HISTORIC AND DESIGN REVIEW COMMISSION

January 19, 2022

HDRC CASE NO: 2021-641
ADDRESS: 142 E AGARITA AVE
LEGAL DESCRIPTION: NCB 1701 BLK 4 LOT E 37.5 FT OF 11 & W 25 FT OF 12
ZONING: R-4,H
CITY COUNCIL DIST.: 1
DISTRICT: Monte Vista Historic District
APPLICANT: Jesse Zuniga
OWNER: Maria Cherry/CHERRY ROBERT N JR &
TYPE OF WORK: Front porch enclosure and handrail installation
APPLICATION RECEIVED: December 09, 2021
60-DAY REVIEW: Not applicable due to City Council Emergency Orders
CASE MANAGER: Stephanie Phillips
REQUEST:

142 E Agarita Ave
Precedent image
screen porch and awnings

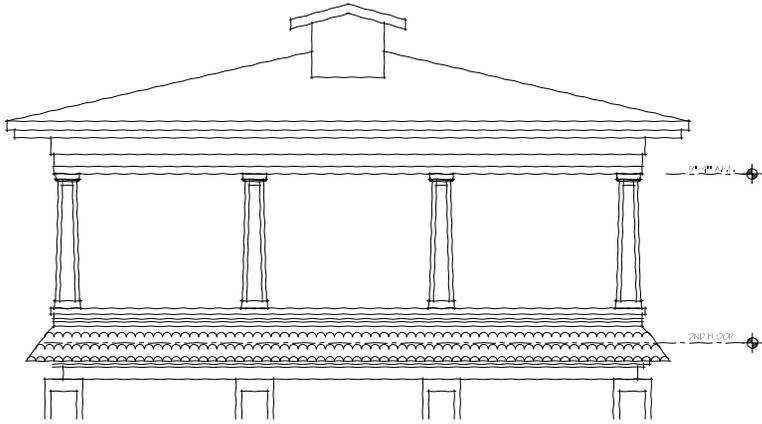
- c. PORCH SCREENING – The applicant has proposed to screen the second story of the front porch with removable fabric insect screening. The applicant has provided photos from 20+ years ago that indicate that the second-floor porch was previously enclosed with more substantial screening. Per the Guidelines, enclosing front porches should be avoided. Approved screen panels should be simple in design as to not change the character of the structure or the historic fabric and should not feature a dark or opaque tint. Original architectural details should not be obscured by any screening or enclosure materials. Alterations to porches should result in a space that functions, and is visually interpreted as, a porch. Staff finds the screening consistent with the Guidelines in this specific circumstance due to the transparent and reversible nature of the screening which results in the porch still visually reading as a porch.

- i. That the applicant submits a material specification for the screening to staff for review and approval prior to the issuance of a Certificate of Appropriateness. The screening shall be transparent, set back behind the porch columns, and not feature a dark or opaque tint. Original architectural details, such as columns, windows, and doors, shall not be obscured by any screening or enclosure materials.

BALCONY ELEVATION-NEW

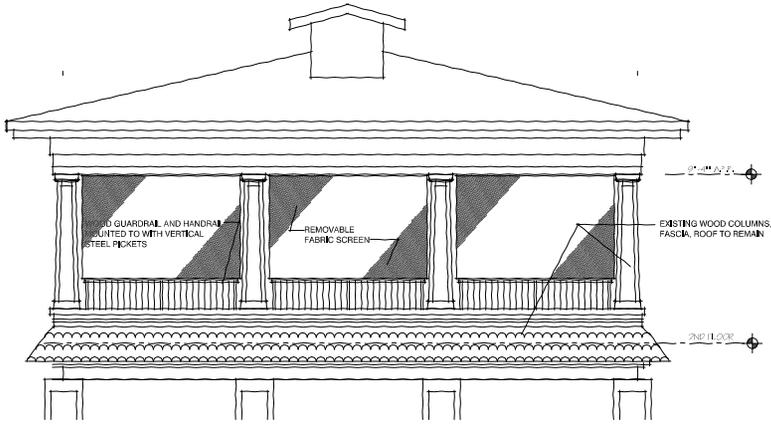
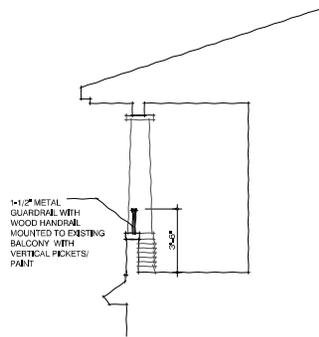
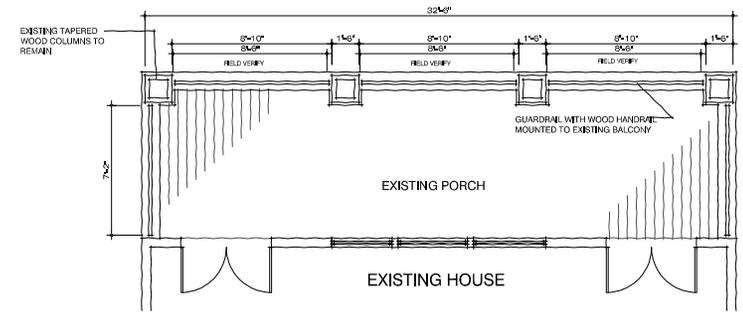
- b. PORCH RAILING – The applicant has proposed to install a wooden railing atop an existing 21” pony wall on the second-floor porch to achieve a railing height that is to modern code. The railing features a simple post and rail design that is compatible with the primary structure in design but not visually competing with existing historic features. Staff finds the proposal consistent.
